Reference: Trail Ridge Landfill - Class I and Class III
Request for Additional Information
FDER # 182117
ET&M NO. E89-113-8

REVIEW MEMORANDUM

SUBJECT: Duval County - Solid Waste
Trail Ridge Landfill - Class I & III Construction
Review of Permit Application No. 182117

RESPONSE TO REQUEST FOR ADDITIONAL INFORMATION

Proj No.	89-395
Date	7/16/90
Scale	1"=150'
Drawing No.	FIGURE ONE

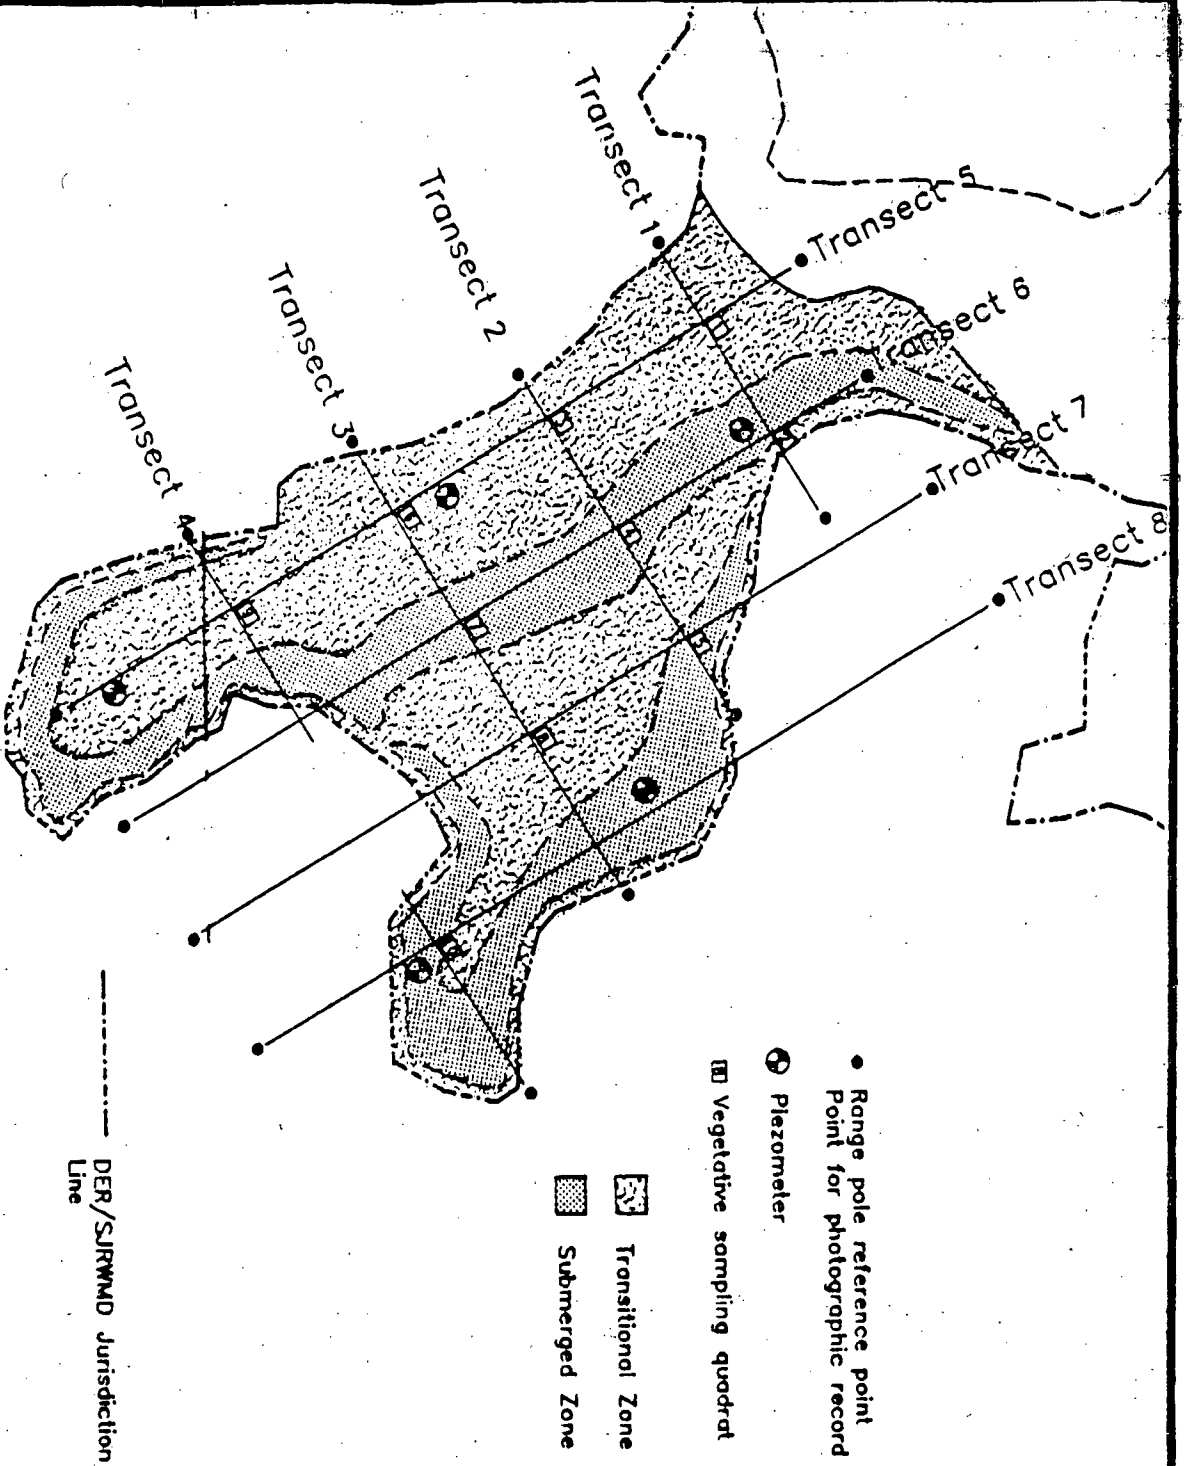
- o The sampling plan for determining mitigation success and natural recruitment will be analyzed by establishing eight permanent line transects (Figure 1, enclosed). They will be equally spaced, and four will be on the north-south axis of the mitigation area and four will be on the east-west axis of the mitigation area. Data will be collected by measuring the relative cover and species diversity along each of the transect lines. A permanent one-meter square quadrat will be established in the northeast quadrant of the intersection of the lines (sixteen quadrants). Six piezometers will be established adjacent to selected quadrats to collect groundwater data. Species diversity and approximate cover will be analyzed for each quadrat. Photographic records will be made of each quadrat. Photographic records will be made at the mitigation area from each point where the transects intersect the edge of the creation area.

PROJ. NO. 89-113
 DATE JULY 14, 1990
 SCALE 1"=10'
 DRAWING NO. 20

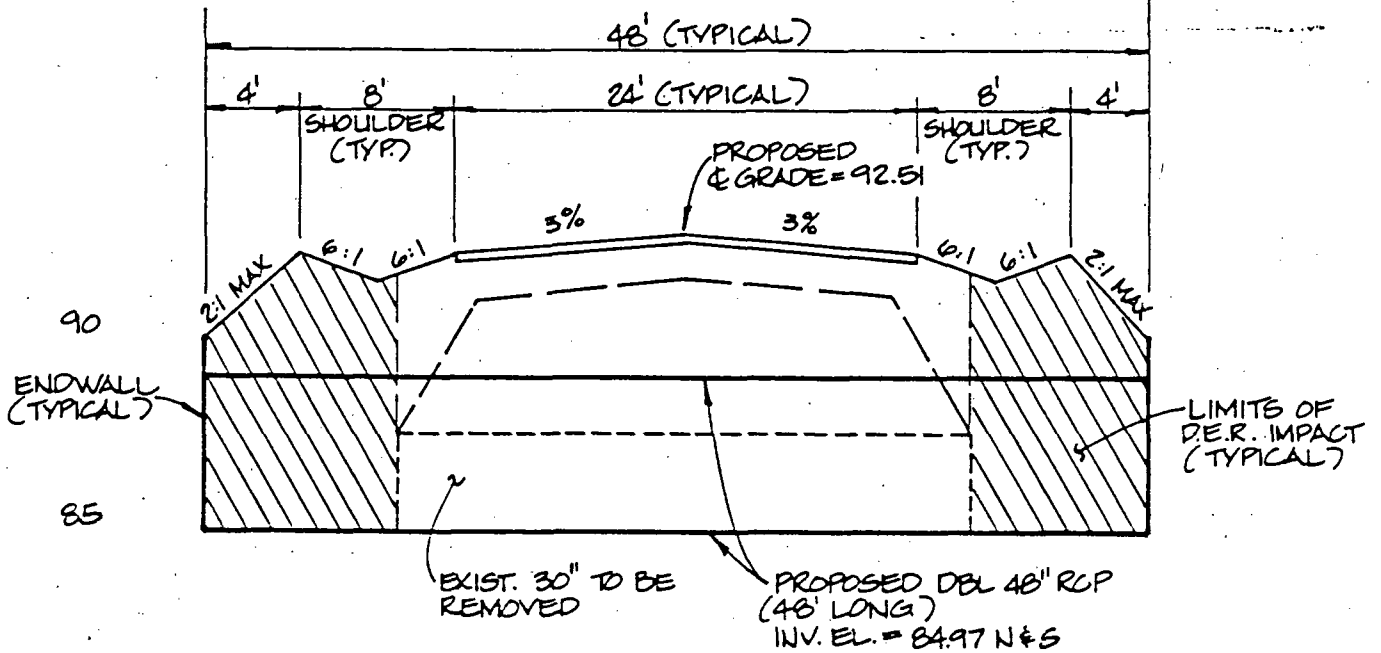
QUESTION 3: Please clarify why the ditch shown on Drawing No. 15 is not within the Department's Wetland Resource Management permitting jurisdiction.

RESPONSE 3: This ditch would not be under DER jurisdiction due to its cross-sectional area being less than 35 S.F. However, it is jurisdictional based on Water Management District criteria. The mitigation area will be excavated to the appropriate depth (12" to 24") of the ditch which will allow sheet flow of the ditch water through the mitigation area.
